## ORIGINATION FORM

Proposed Revisions to a Standard Plans Index  
(Please provide all information — Incomplete forms will be returned)

Index Number: 654-001  
Sheet Number (s): 1 of 1  
Index Title: Rectangular Rapid Flashing Beacon Assembly

**DETAIL "A"**

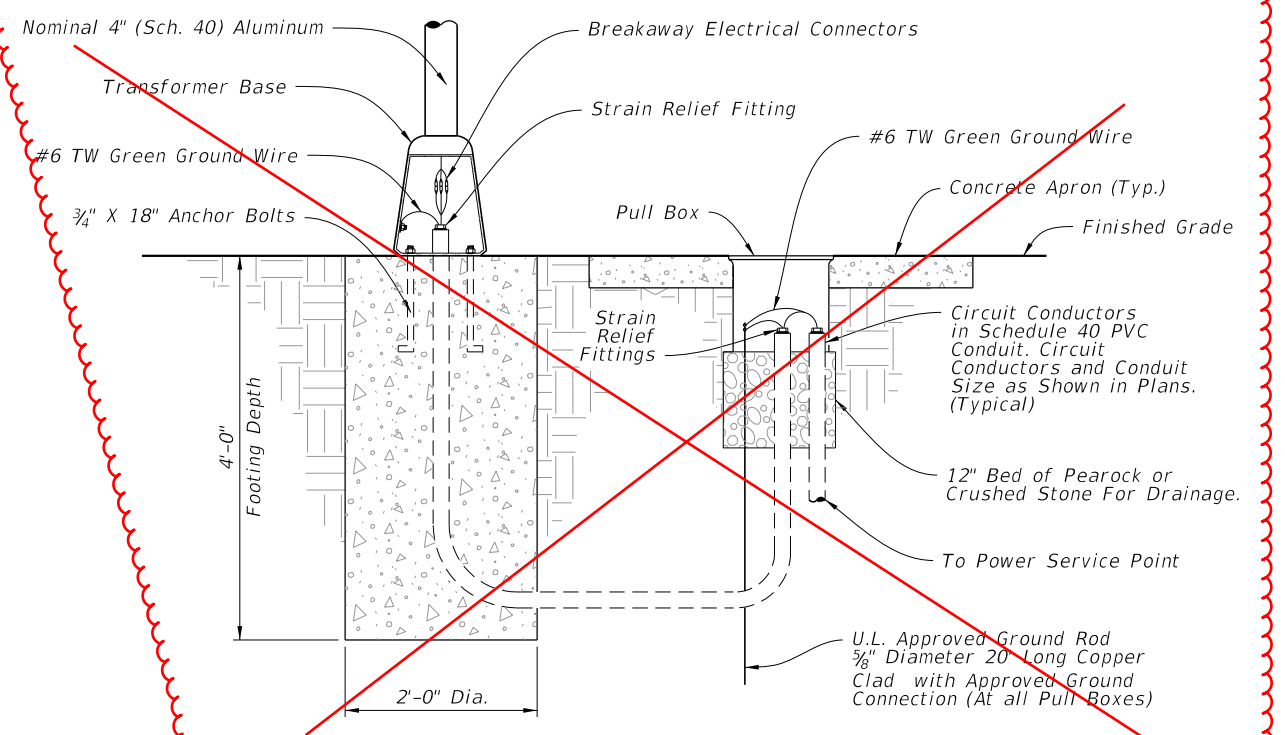
**REORGANIZED SHEET TO SHOW BEACON ASSEMBLY ADJACENT TO SIDEWALK**

**POLE WIRING AND FOOTING DETAIL**

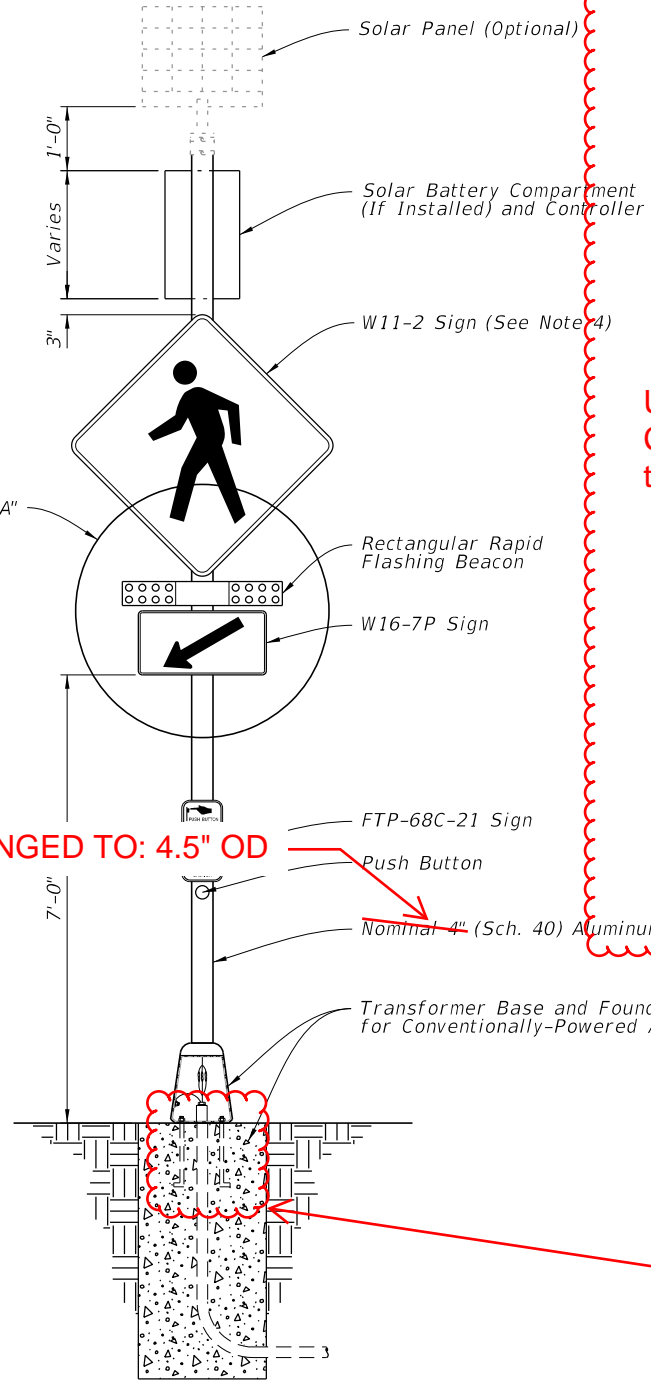
**DELETED DETAIL "B" AND ADDED REFERENCE TO INDEX 700-120 NOTE 1.**

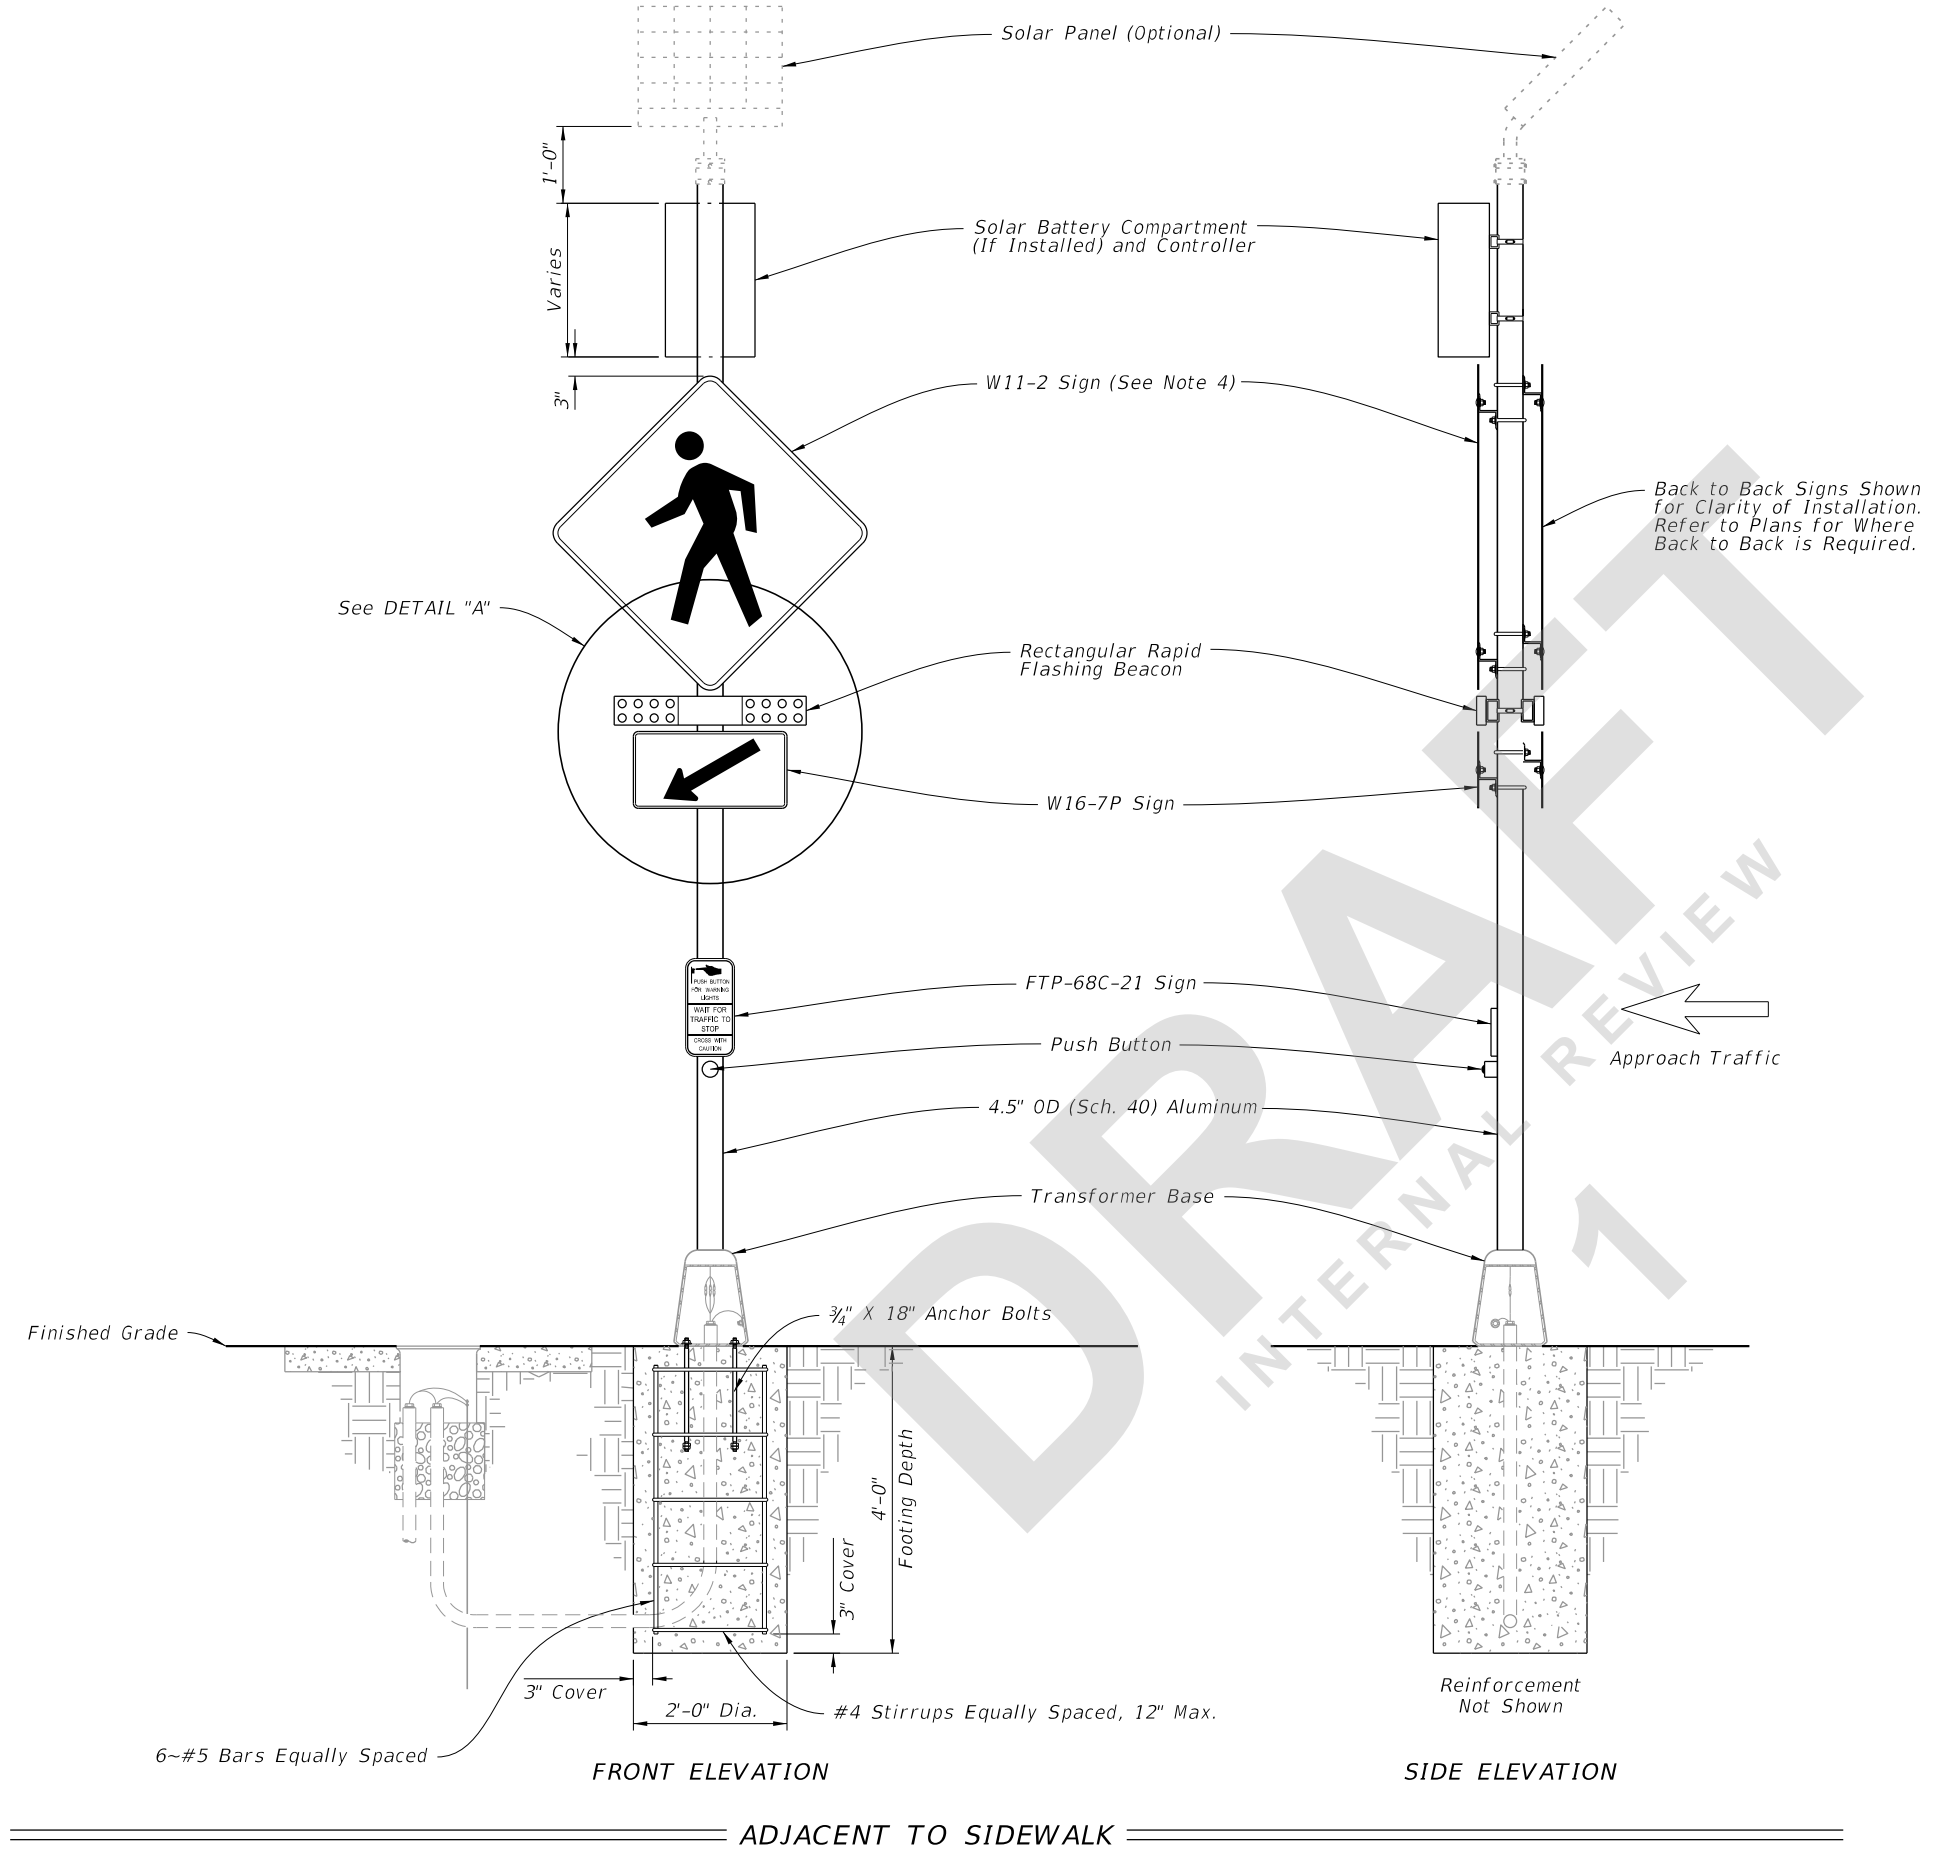
**UPDATED: Callout to point to both details**

**UPDATED: Anchor Bolts**

INDEX 654-001	SHEET 2 of 2
------------------	-----------------

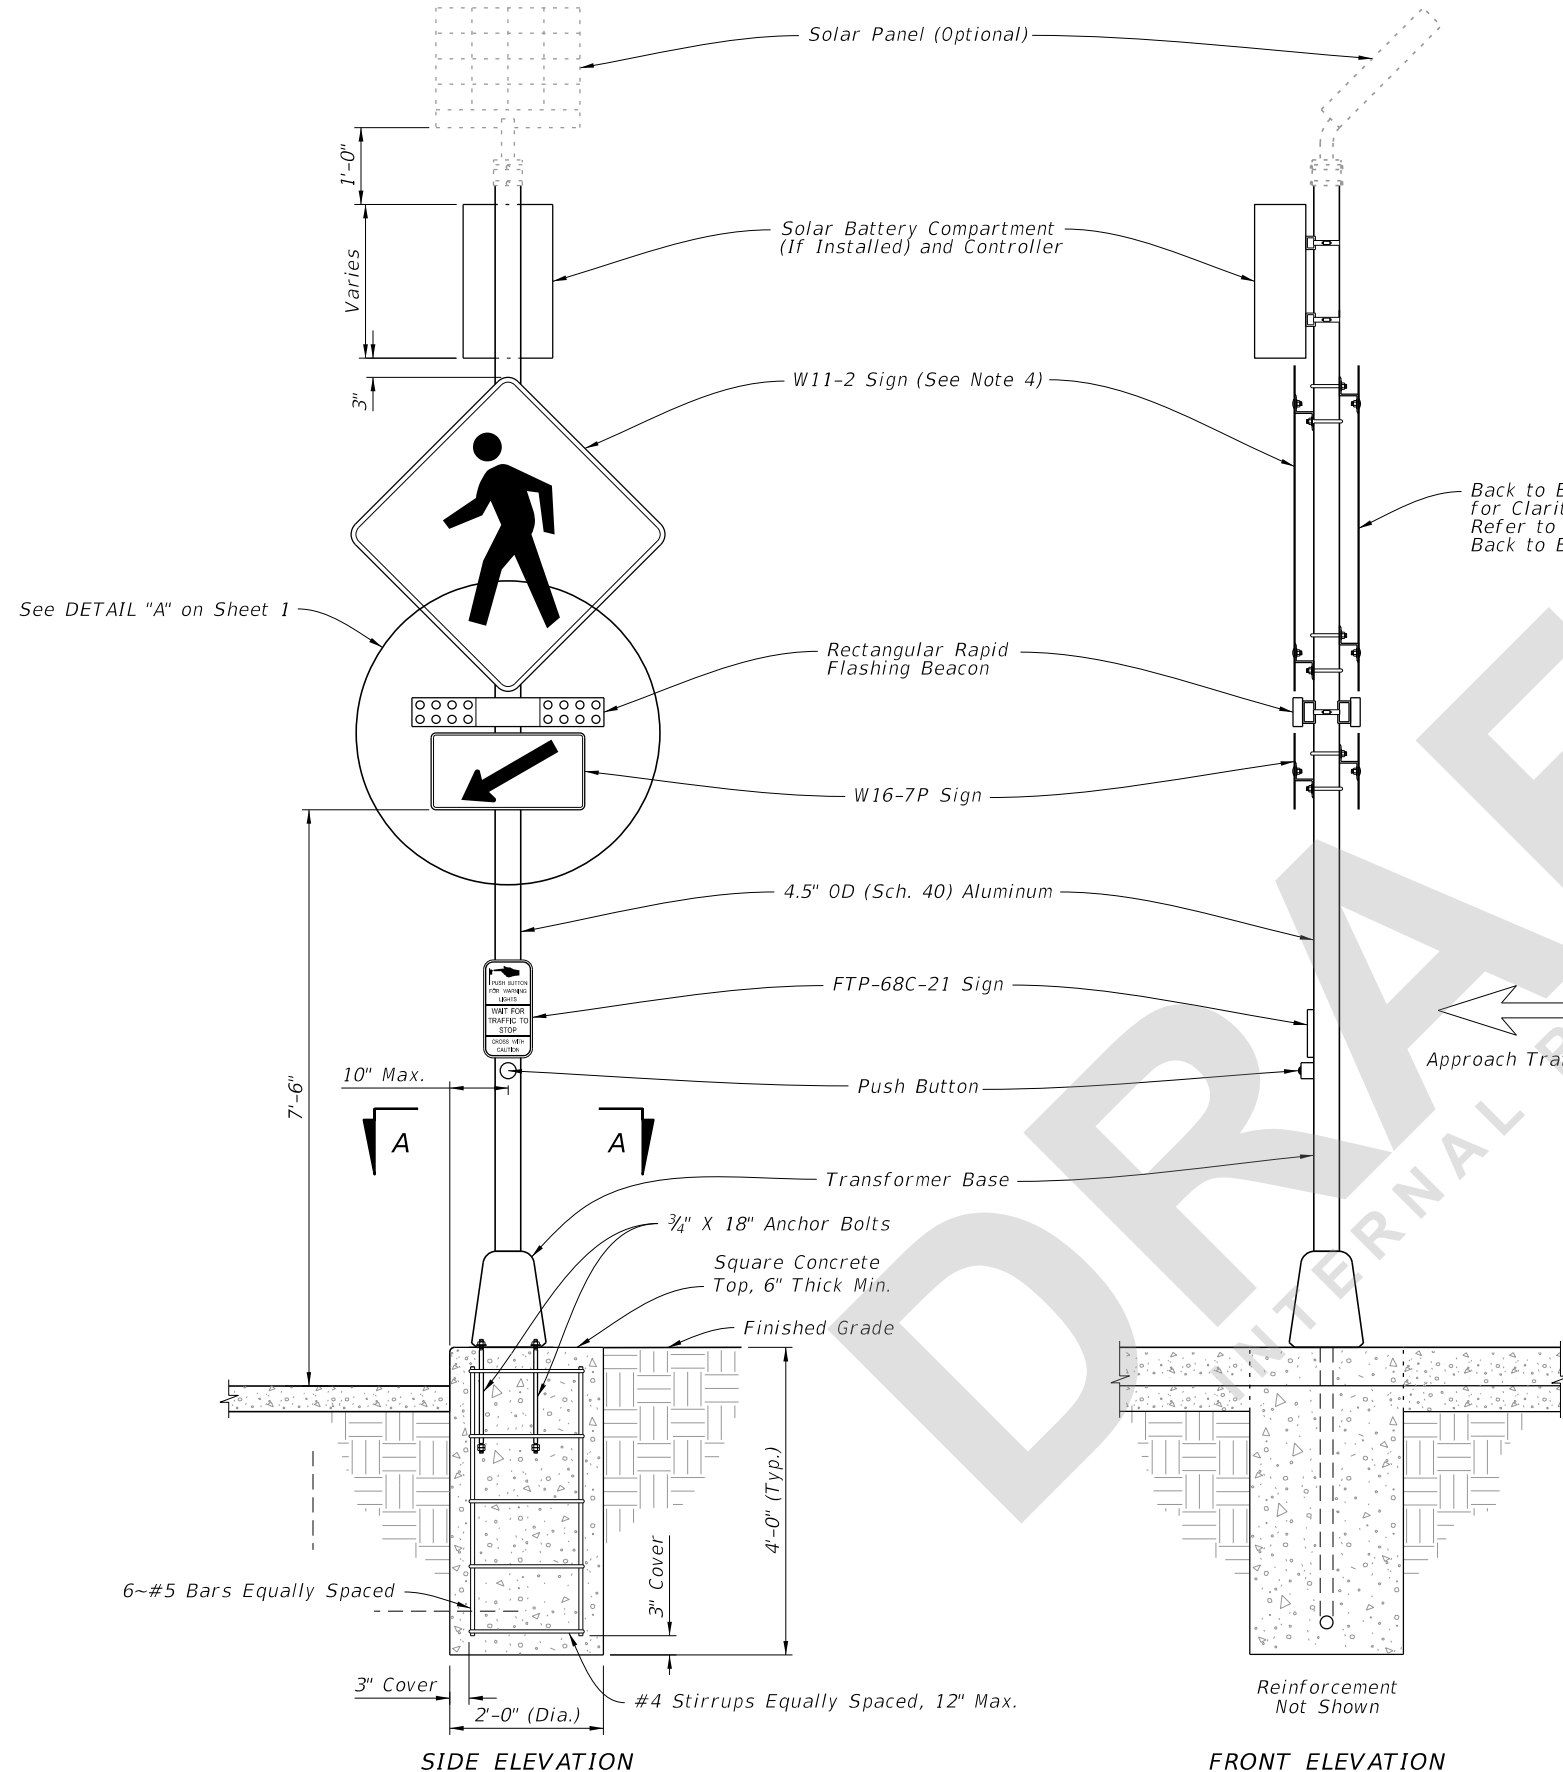
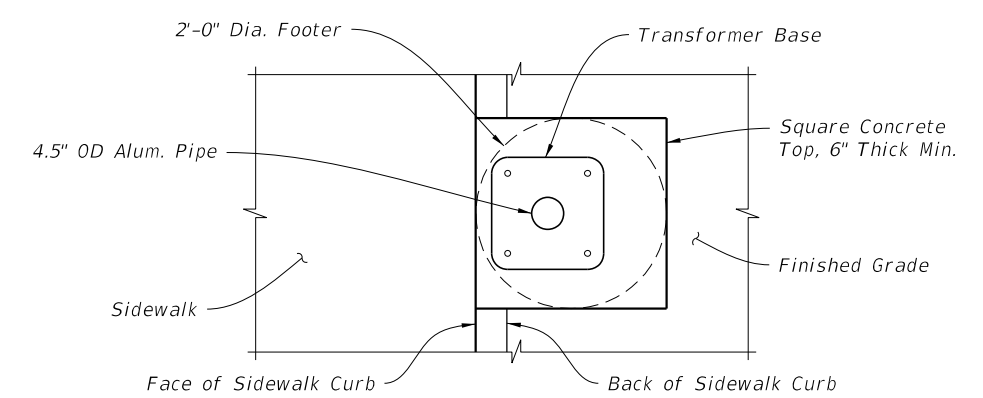
Sheet 2: (New Sheet) showing the Beacon Assembly in the Sidewalk Curb.

# NEW SHEET

SHOWING BEACON ASSEMBLY IN SIDEWALK CURB
